**LANDING GEAR - BRAKE CONTROL UNIT (BCU PN 90005034-8) - REPLACEMENT FOR AIRCRAFT
EQUIPPED WITH BCU-7 (BCU PN 90005034-7)**

This service bulletin supersedes the SB500-32-0016.

FIGURE 1 - BRAKE CONTROL UNIT (BCU) - REPLACEMENT
(Sheet 1 of 1)

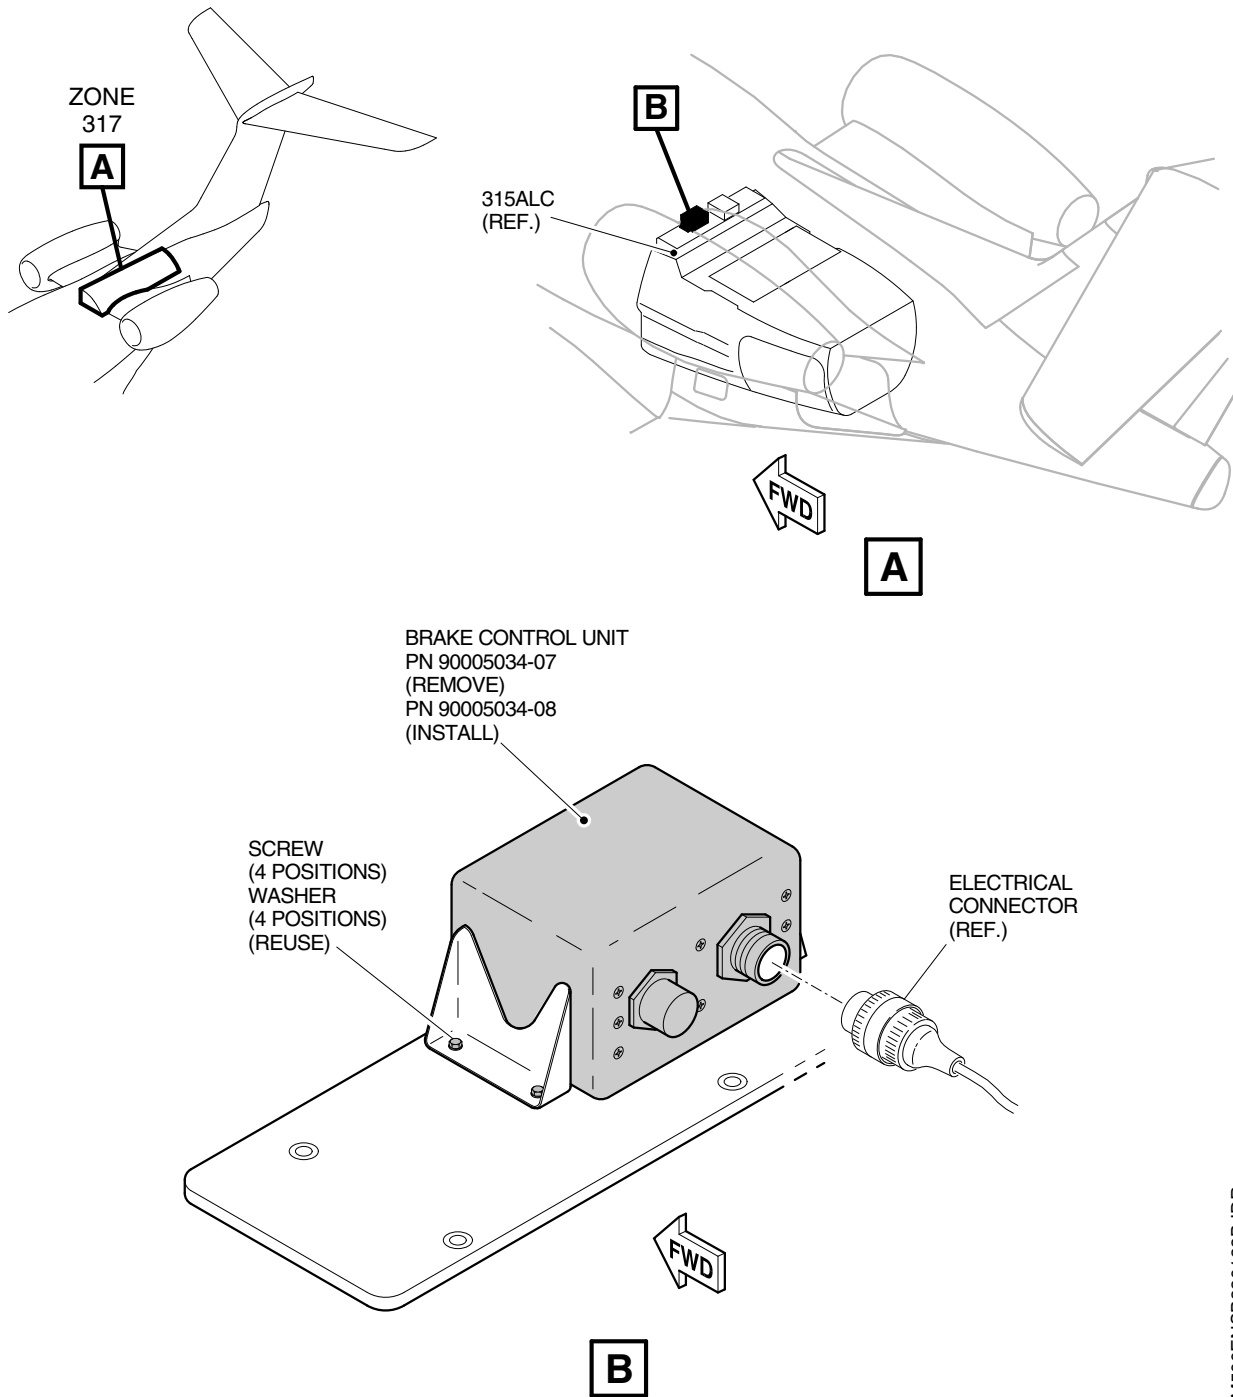
The new Brake Control Unit software removes the switching between independent and paired control that could lead to an asymmetrical braking during landing. It also adds field loadable property and corrects the locked wheel function implementation.

This bulletin consists of the replacement of the Brake Control Unit PN 90005034-7 with a new improved one bearing PN 90005034-8, which has an updated software.

- A. Make sure that the aircraft is safe for maintenance. Refer to [AMM TASK 20-00-00-910-801-A/200](#) - Aircraft Maintenance Safety Procedures.
- B. Remove the existing Brake Control Unit PN 90005034-7 according to the instructions given in according to instructions given in [AMM TASK 32-41-01-000-801-A/400](#) - Brake Control Unit - Removal.

- C. Install the new BCU 90005034-8 according to instructions given in [AMM TASK 32-41-01-400-801-A/400](#) - Brake Control Unit - Installation.
- D. Enter the accomplishment of this service bulletin in the applicable documents.
- E. Please use the online SB evaluation form available on the MyTechcare portal (<http://www.techcare.embraer.com>). Go to "Maintenance > eTechPubs > Utilities > SB Evaluation Form" to inform us about the SBs that you have incorporated in your fleet, as well as the difficulties found during the SB incorporation.
